Product Change Notification

Change Notification #: 119033-01

Change Title: Select Intel® Ethernet Network Adapter E810-2CQDA2,
Intel® Ethernet Network Adapter E810-CQDA2,
Intel® Ethernet Network Adapter OCP3.0 E810-CQDA2,
Intel® Ethernet Network Adapter OCP3.0 E810-XXVDA2,
Intel® Ethernet Network Adapter OCP3.0 E810-XXVDA4,
Intel® Ethernet Network Adapter OCP3.0 E810-CQDA1,
Intel® Ethernet Network Adapter E810-XXVDA4,
Intel® Ethernet Network Adapter E810-XXVDA2,
Intel® Ethernet Network Adapter E810-CQDA2,
Intel® Ethernet Network Adapter E810-CQDA1,
PCN 119033-01, Product Design,
NVM update to v3.2 and OUI update
Reason for Revision: Updating one affected SKU in the table under bullet #2, and including additional Regulatory Marking Label Changes for the affected SKUs in bullet #3 under the “Description of Change to the Customer”

Date of Publication: August 14, 2023

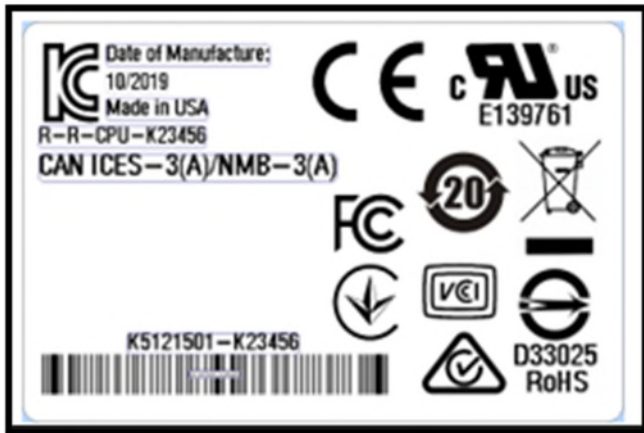
3. In addition to the change above, Intel will implement a Regulatory label marking change to the following SKU's. The change adds the UKCA marking (See below)
